BCA ASSESSMENT REPORT

Heritage Motors – Bungaree Street, Maitland

Project Number: 117280

Report Type: BCA

Existing Showroom

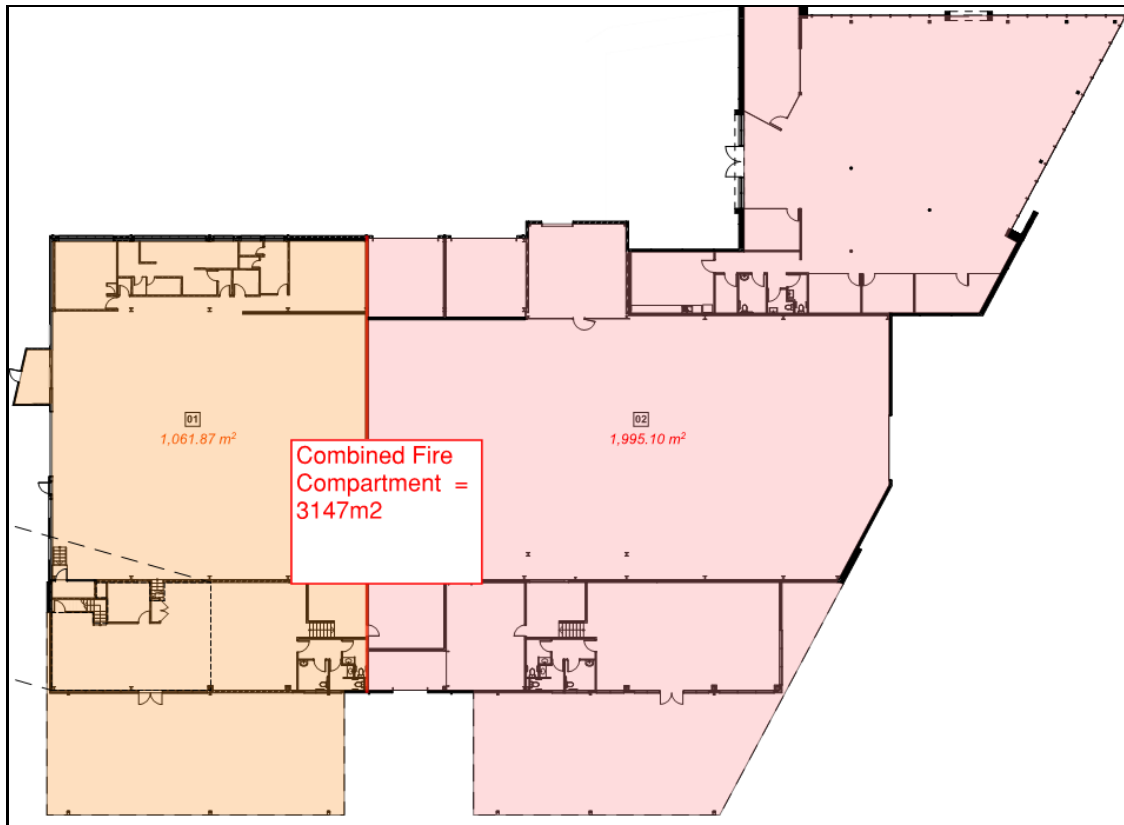
The existing Mitsubishi showroom has a combined fire compartment size of 900m² across both storeys and is permitted to be Type C Construction.

Workshop and Kia Showroom

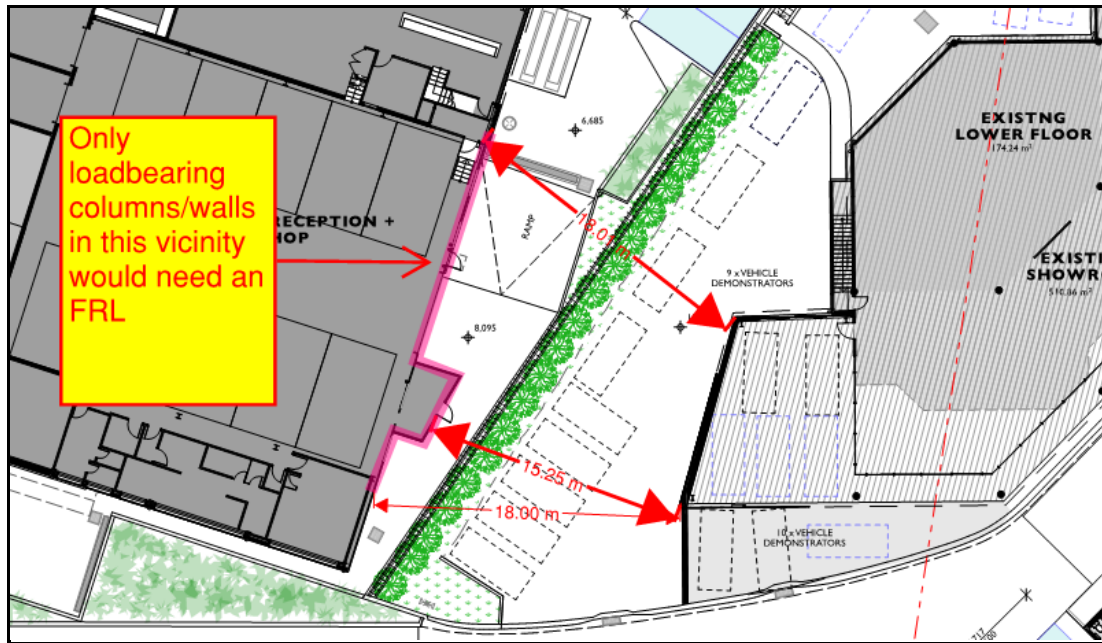
The existing workshop is proposed to be extended towards the south for an enlarged workshop and a second service reception area. In addition, a new car showroom is proposed (Kia) to the south eastern corner of the building. As a result, the overall fire compartment floor area is 3147m² which is greater than 2000m² permitted for Type C Construction and would trigger Type B Construction which has a maximum fire compartment floor area of 3500m²/21,000m³.

In this instance it is recommended to retain Type B Construction instead of inserting a fire wall to reduce the fire compartment floor area/volume which would be more onerous than accepting Type B Construction.

Due to the boundary setbacks on most elevations being more than 18 metres, the only Fire Resistance Levels would be to the loadbearing external wall/columns nearest the Mitsubishi showroom where the setback is 15 -18 metres as per the following location.

- a. The mezzanine floor does not need any FRL. However, internal loadbearing columns to the lowest floor level would in theory require FRL. This would only be a small number of internal columns supporting the mezzanine.
- b. Signage to be non-combustible, or at least achieve a group 1 or 2 Rating as per BCA2022 Clause C2D14 otherwise will need a fire engineered performance solution.
